ARCHITECT'S ADDENDUM

Addendum Number: 003

RE: EASD #131 East Aurora High School
2027 Mechanical Improvements

Subject: Addendum No. 003 to the Construction Documents for the EASD #131 East Aurora High School 2027 Mechanical Improvements Project.

A2-A1.11

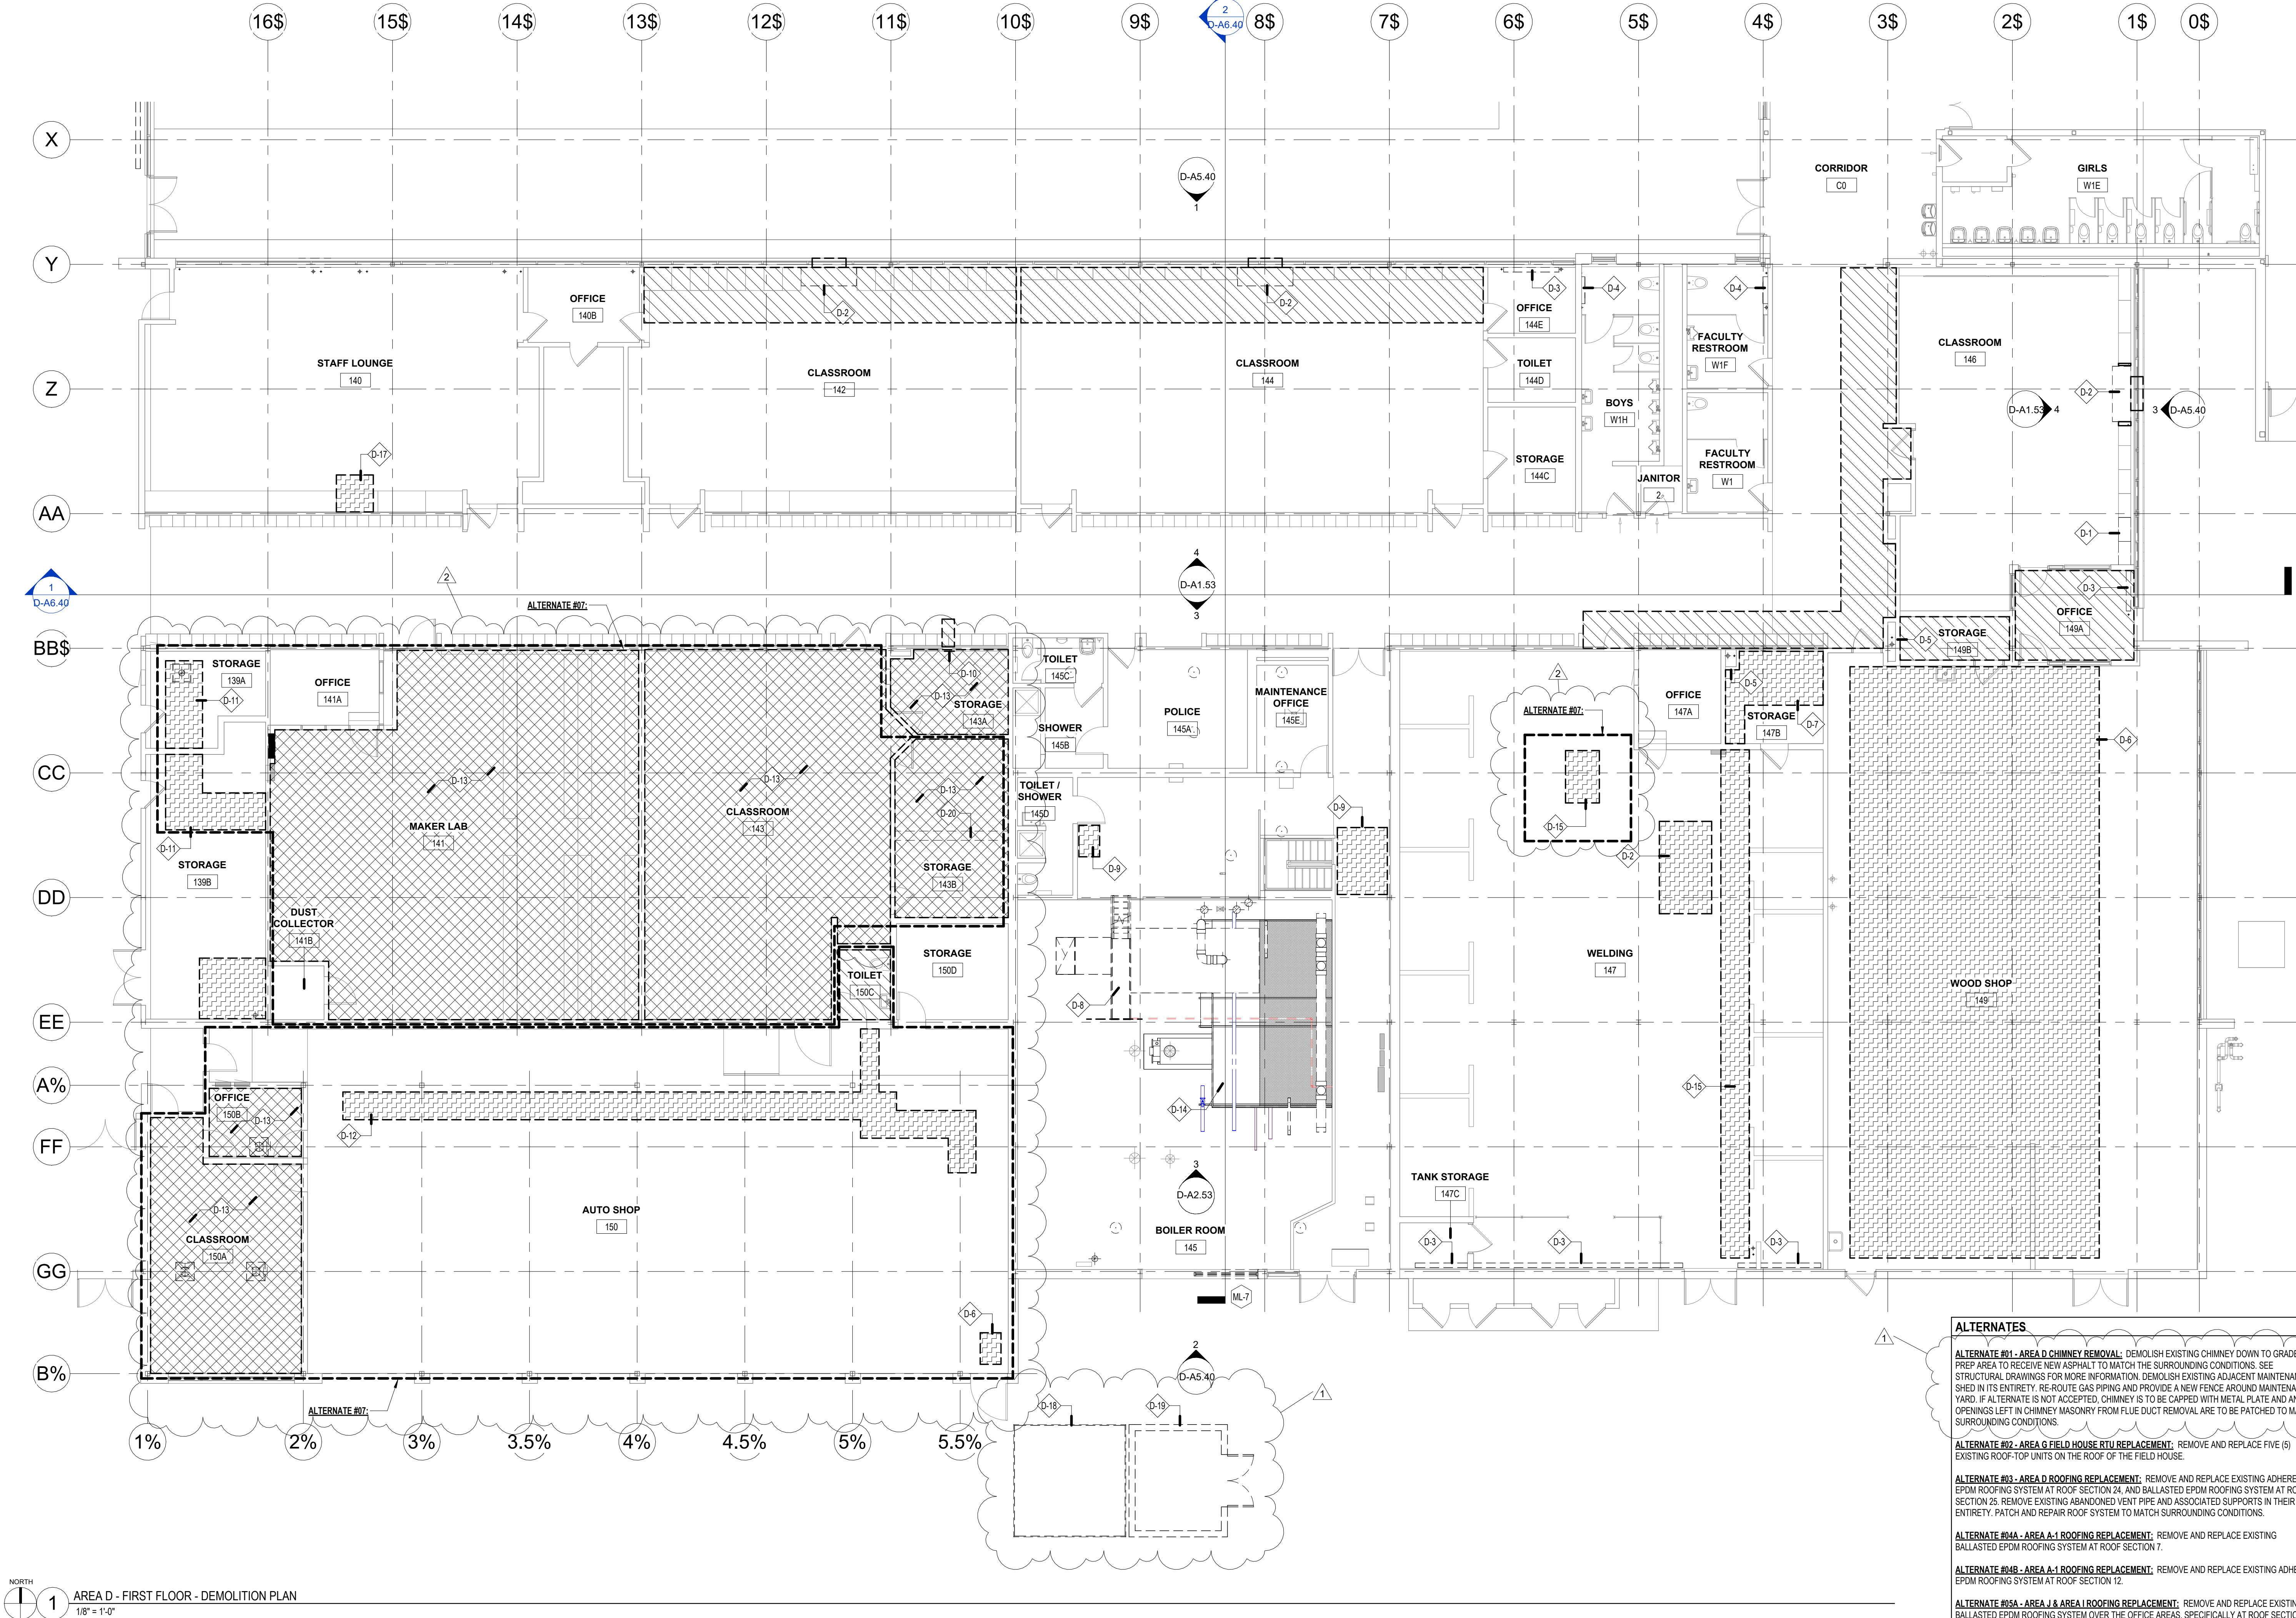
1. A2-A1.11 – AREA A-2 – FIRST FLOOR – DEMOLITION PLAN

- **ADDED** Abatement Coordination Note, “Coordinate coring with others through existing terrazzo floor with abatement contractor. Refer to Exhibit M – Environmental Asbestos Inspection Report for information on locations and testing sample results.”

COORDINATE CORING BY OTHERS THROUGH EXISTING TERRAZZO FLOOR WITH ABATEMENT CONTRACTOR. REFER TO EXHIBIT W - THE ASBESTOS INSPECTION REPORT FOR INFORMATION ON LOCATIONS AND TESTING SAMPLE RESULTS.

FIRST FLOOR
MECHANICAL
DEMOLITION PLAN -
AREA D

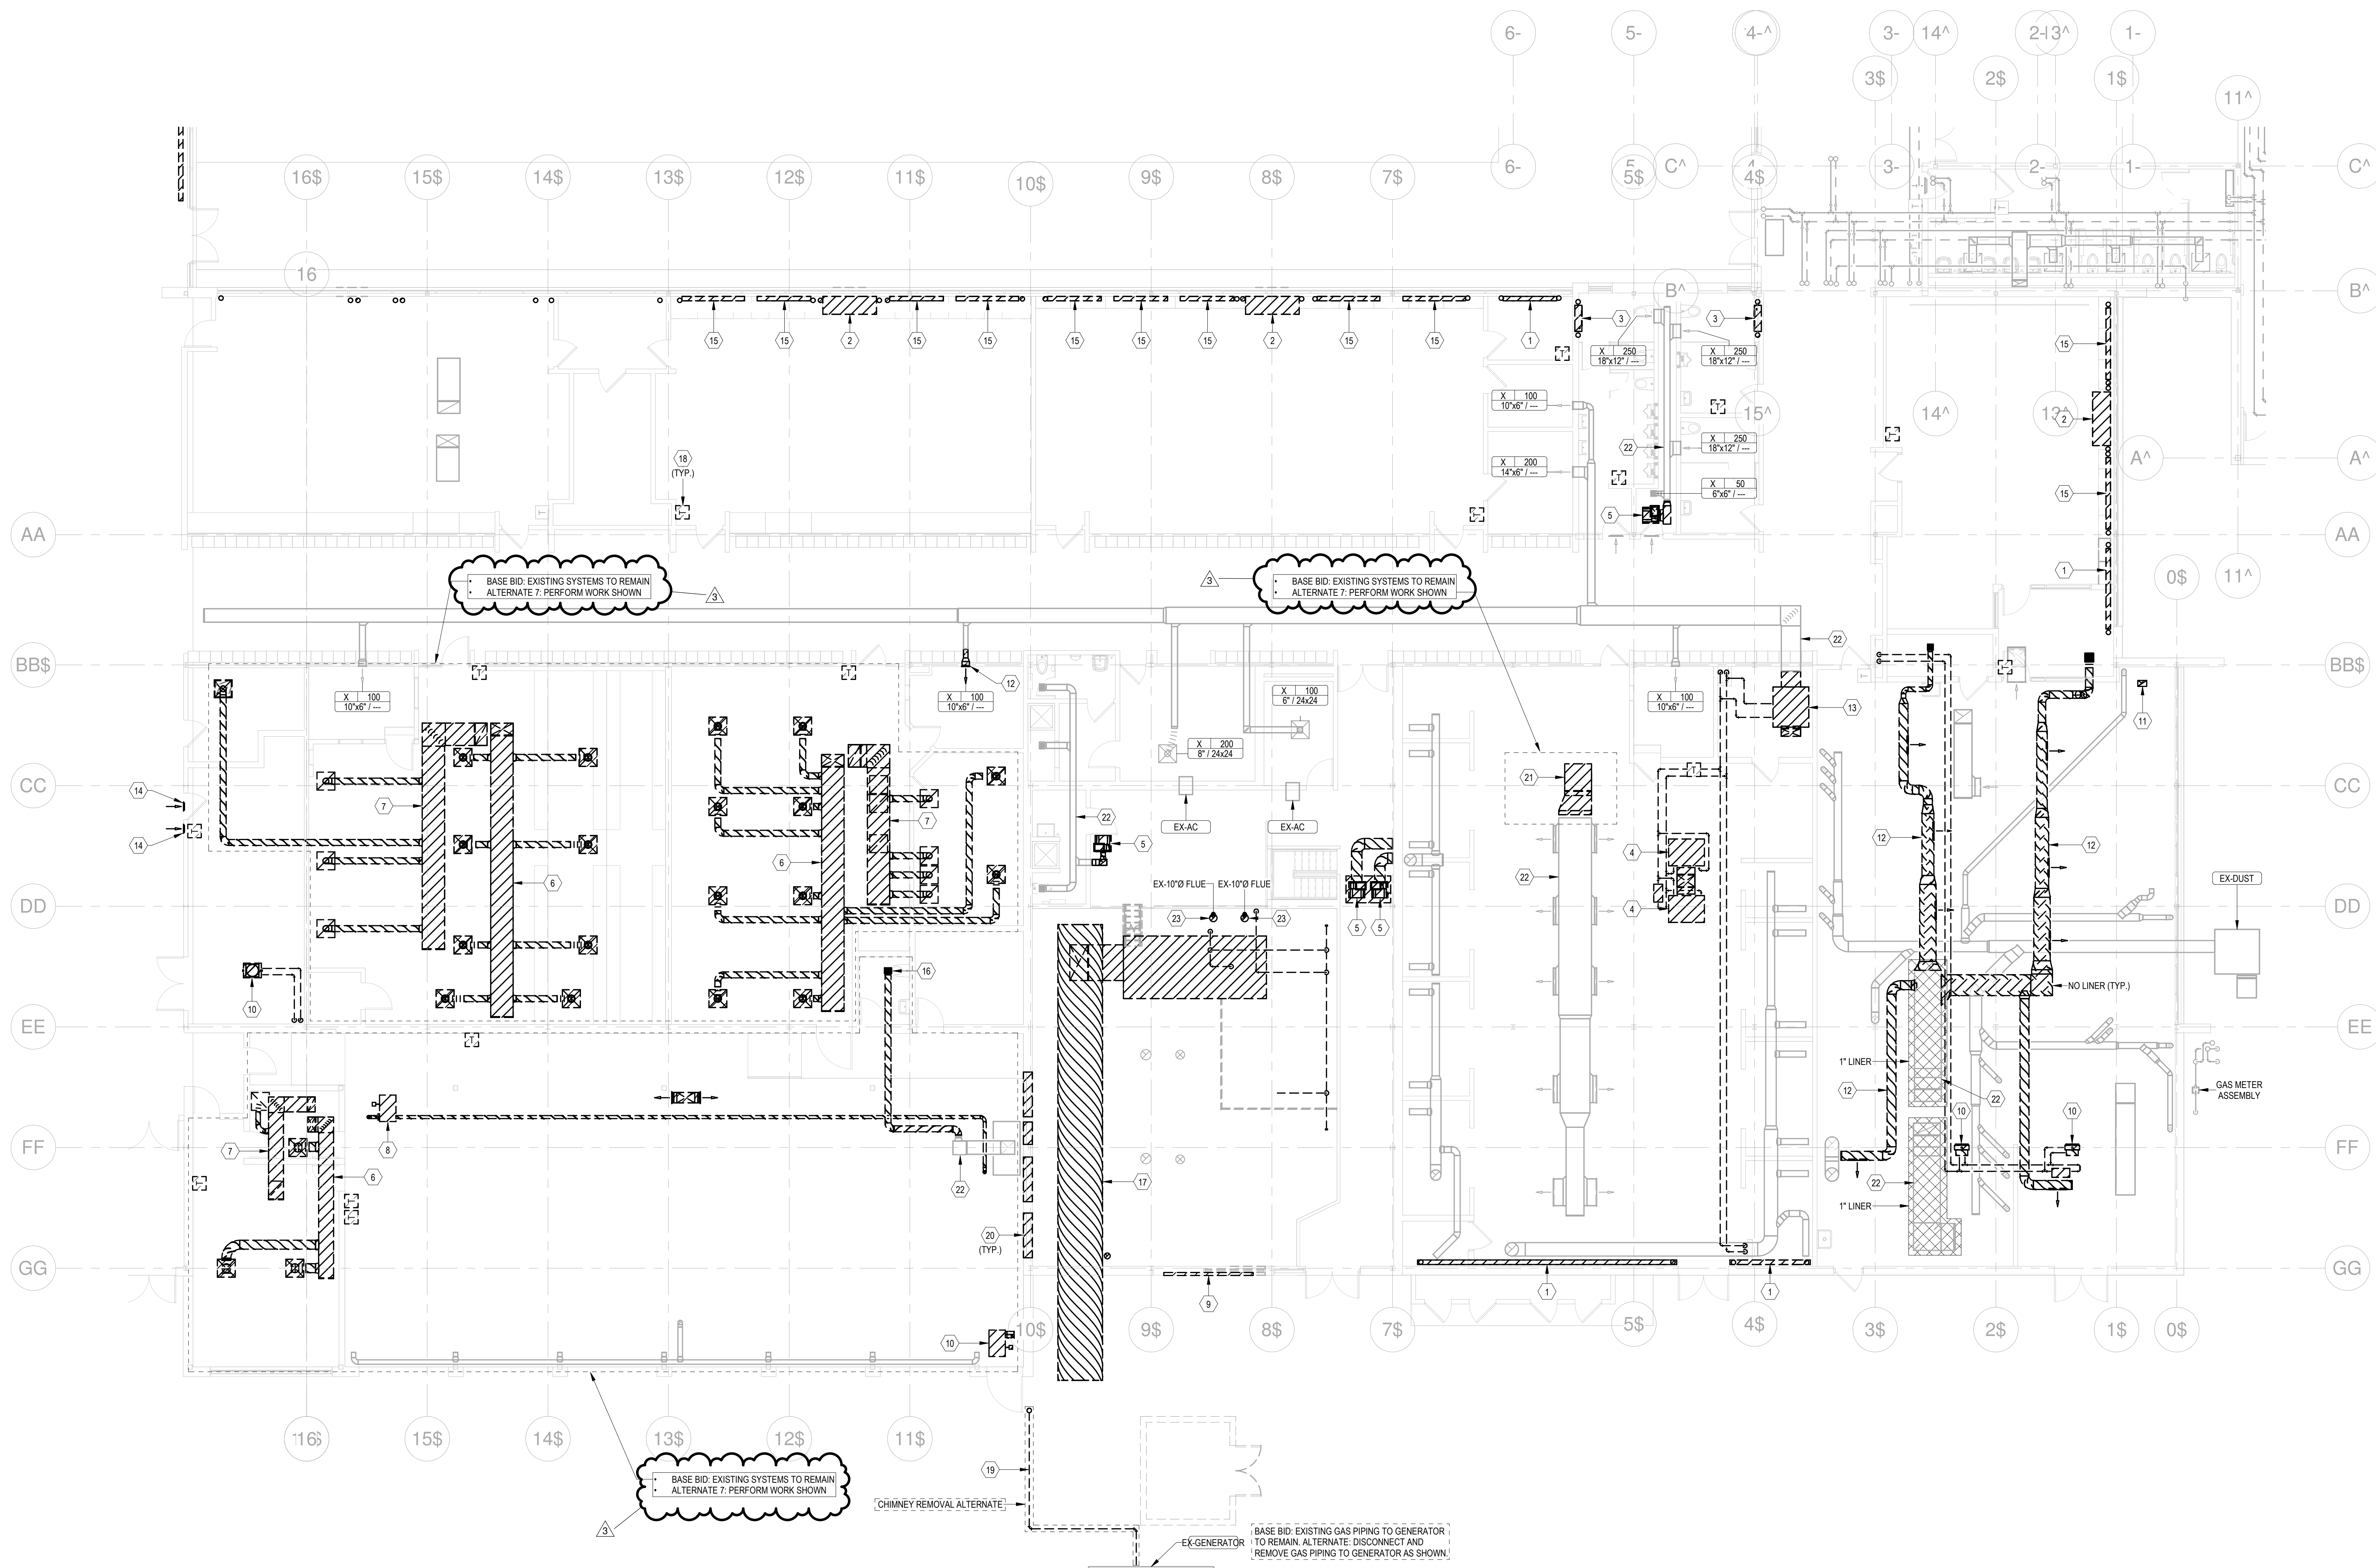
2. D-M1.1 – FIRST FLOOR MECHANICAL DEMOLITION PLAN – AREA D
 - **ADDED** boundaries indicating work that was formerly part of the Base Bid is now part of Alternate #07. Refer to attached sheets for further information.

1 ROOF MECHANICAL DEMOLITION PLAN - AREA D
1/8" = 1'-0"

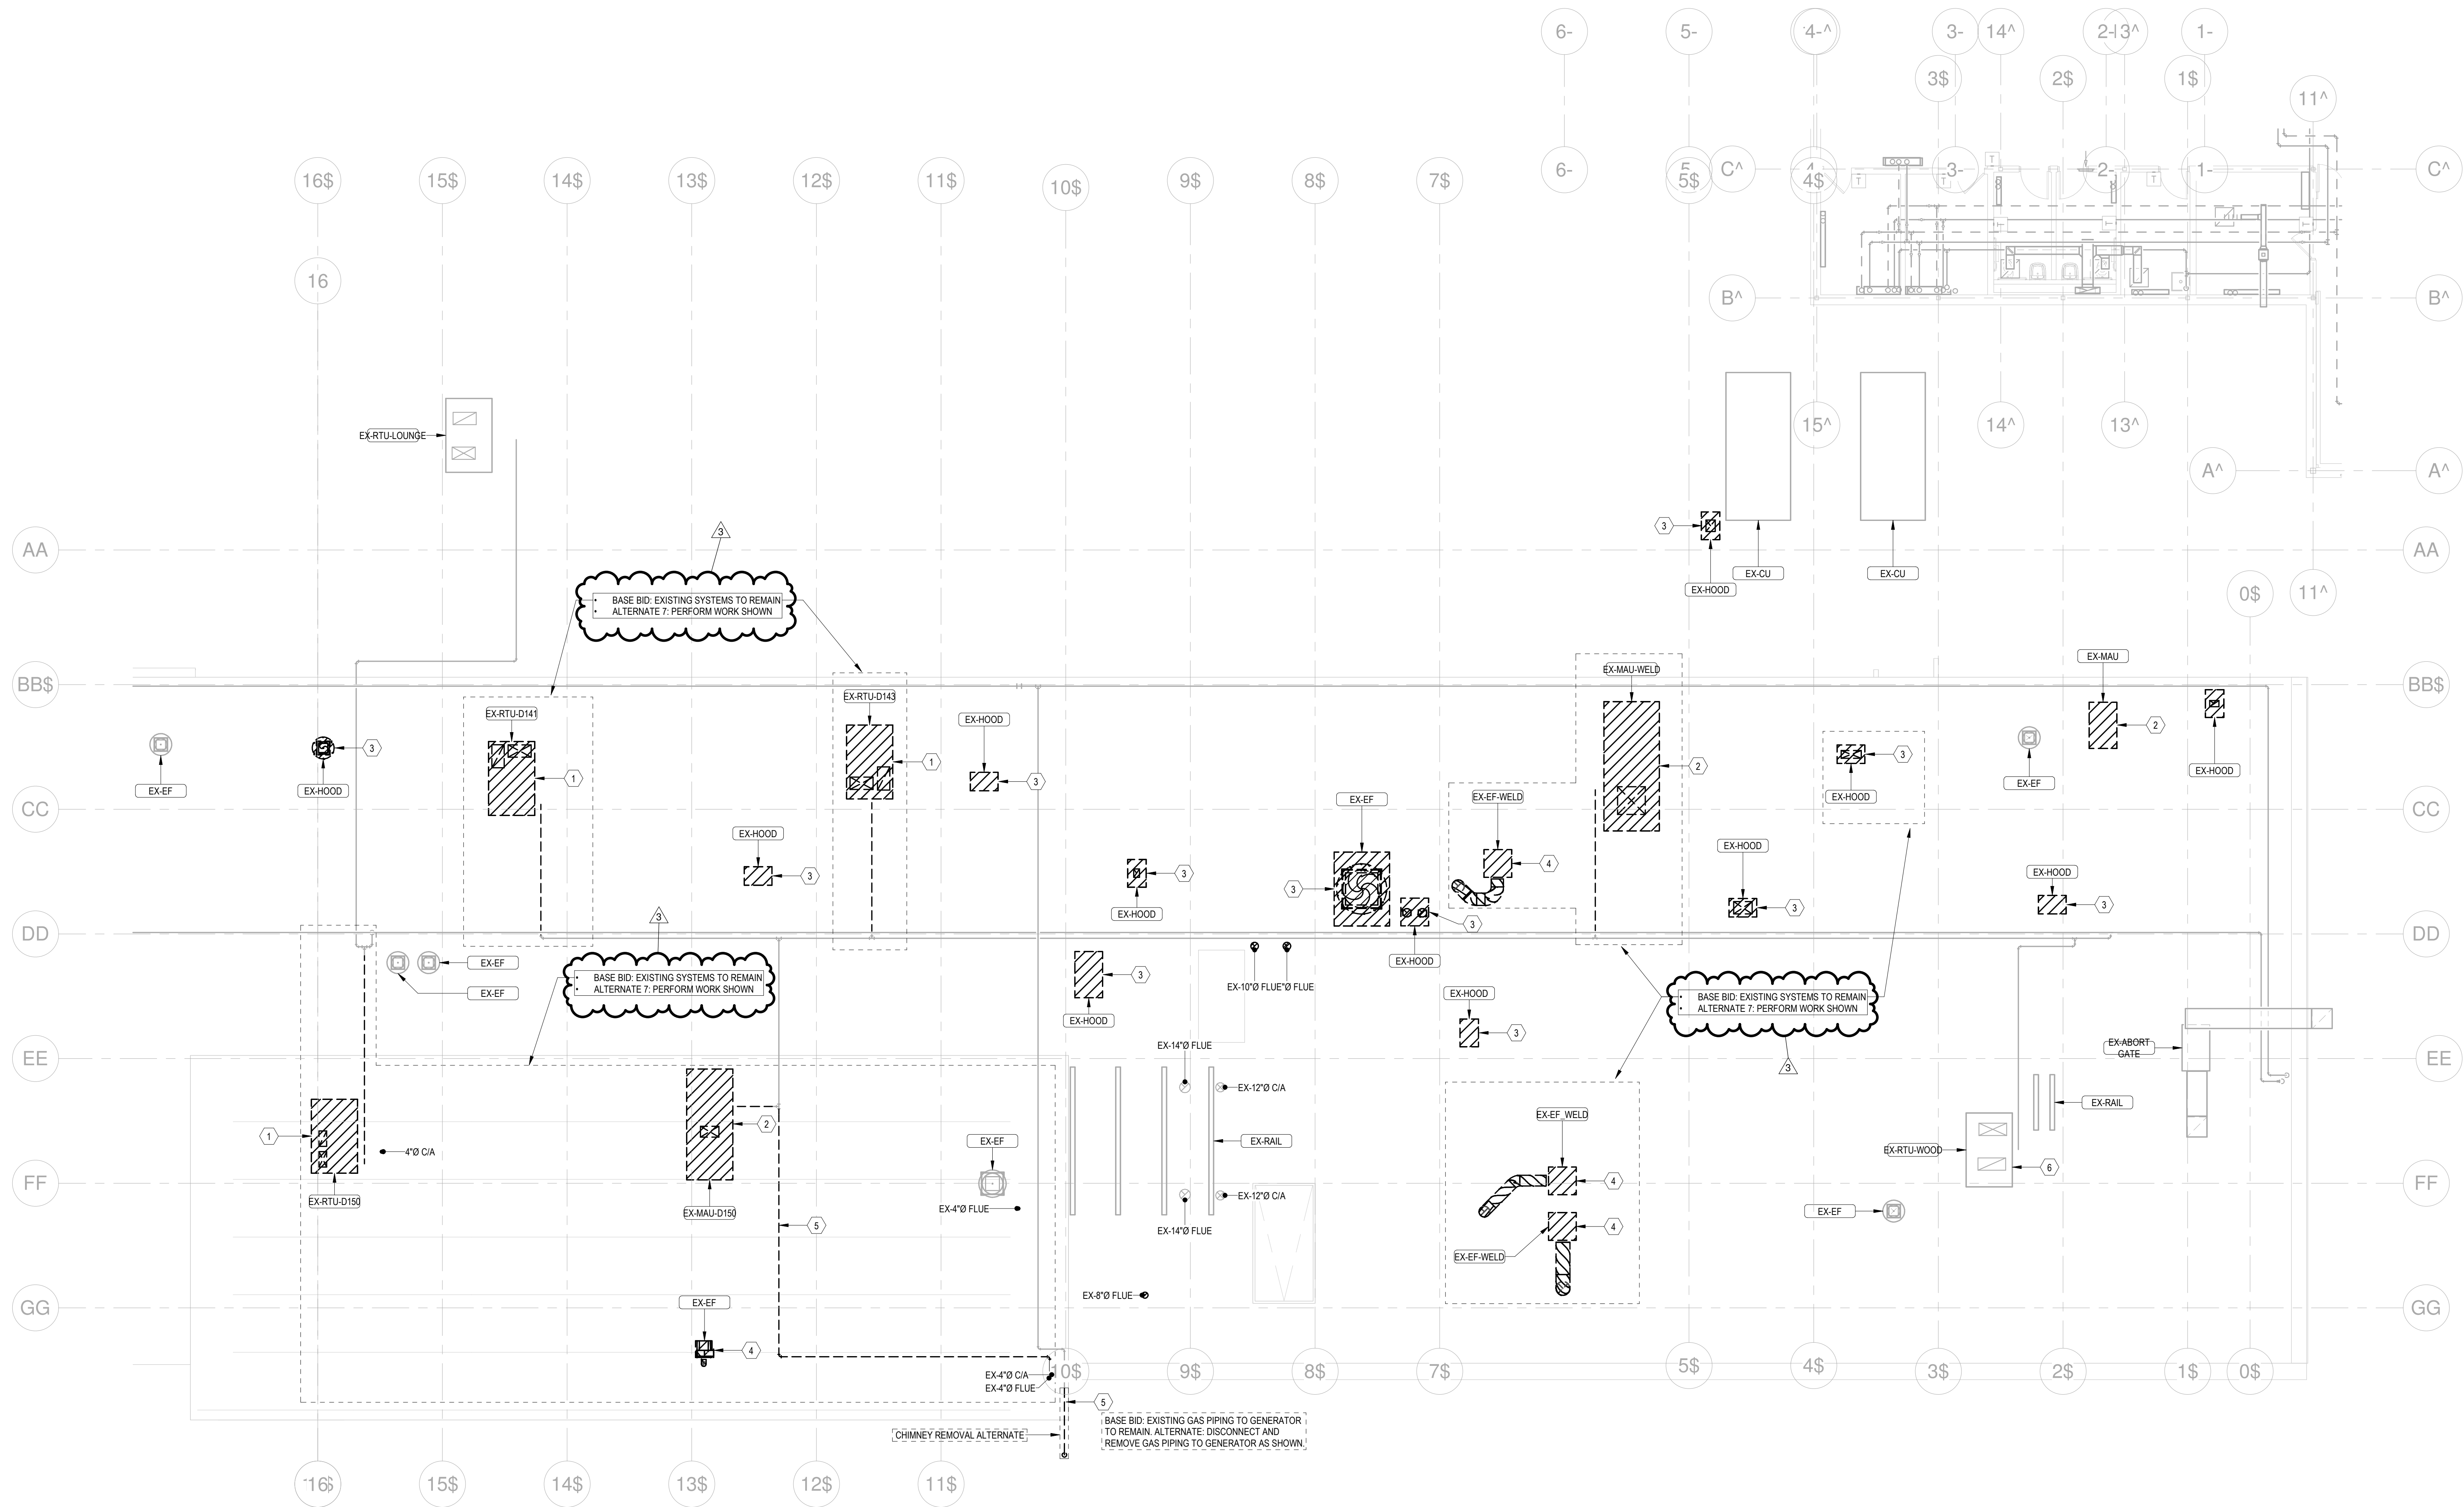
3. D-M1.2 – ROOF MECHANICAL DEMOLITION PLAN – AREA D
 - **ADDED** boundaries indicating work that was formerly part of the Base Bid is now part of Alternate #07. Refer to attached sheets for further information.
